TECHNICAL SERVICE BULLETIN

British Motor Holdings (U.S.A.) Inc.

Re: Right Angled Speedometer Adaptor Failures

WASHER 3H 550

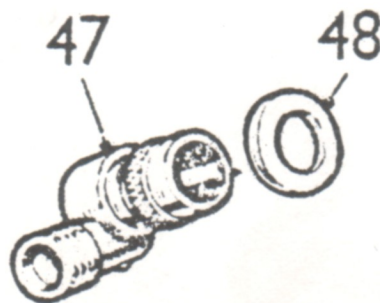
Repeated failures of the above have, in many instances, been caused by Washer-Adaptor to gearbox Part Number 3H 550 not being fitted when a new right angled drive adaptor is installed.

This causes an excessive end load and premature failure of the right angled drive pinion.
